ADVERTENCIA 058/DAG

MOTIVO: Posibilidad de fractura de bielas del motor por hallarse por debajo de las tolerancias mínimas recomendadas por el fabricante.

CATEGORY 2
CSB96-13
 FAA APPROVED
 Supersedes M86-11 Rev.1

SUBJECT: IO-360, TSIO-360 AND LTSIO-360 SERIES ENGINE CONNECTING ROD INSPECTION AND REPLACEMENT.

FIGURE 1. CONNECTING ROD.

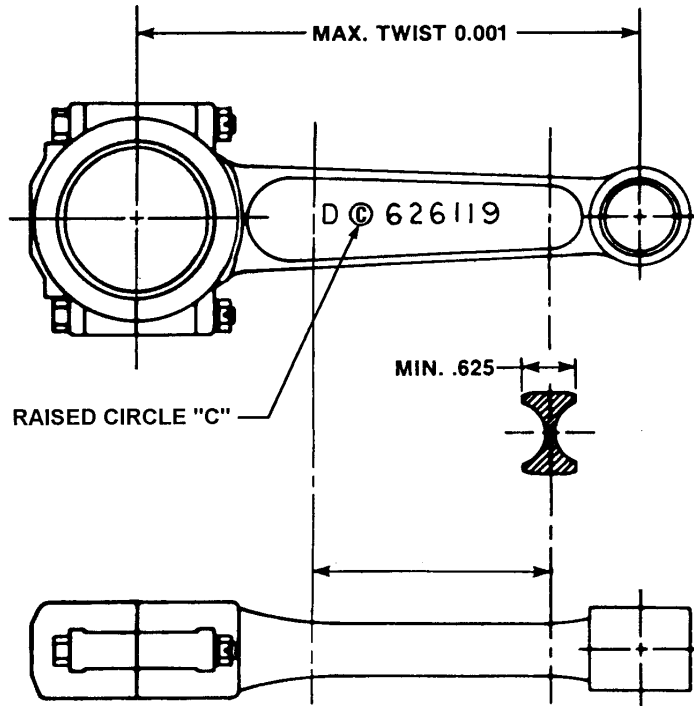
- Remove all cylinders in accordance with the applicable TCM Overhaul Manual.
- Inspect each connecting rod while it is positioned at its maximum stroke to allow clearance from the crankcase. Measure the beam width as indicated in Figure 1 and record the forging number.
- Any connecting rod that has a beam width less than .625 inch must be replaced. See Figure 1.

NOTE: Connecting rods are supplied in pairs due to the maximum weight differential of 14 grams in opposing cylinder bays. Therefore, the opposite cylinder connecting rod will also require replacement. Reference Table 1 for the applicable replacement connecting rod kit.

FIGURE 2
CONNECTING ROD
COTTER PIN INSTALLATION.

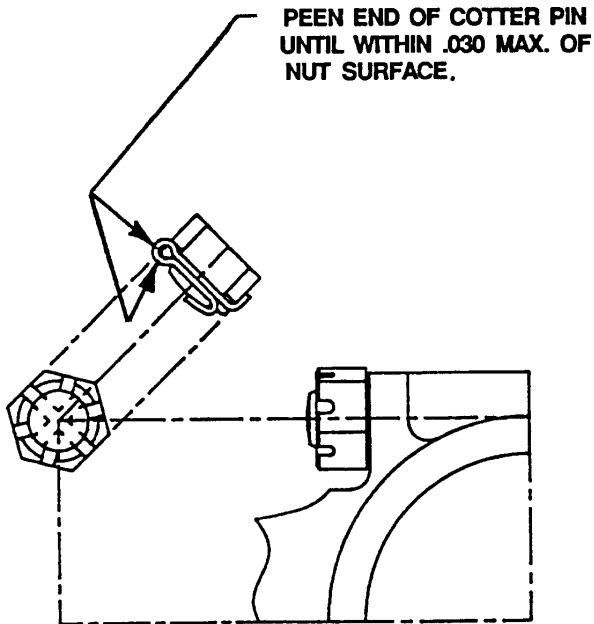
- Install and torque replacement connecting rods in accordance with the applicable TCM Overhaul Manual. Install cotter pins in accordance with Figure 2.
- Reassemble the engine in accordance with the applicable TCM Overhaul Manual. Make a engine log book entry as to compliance with this service bulletin.
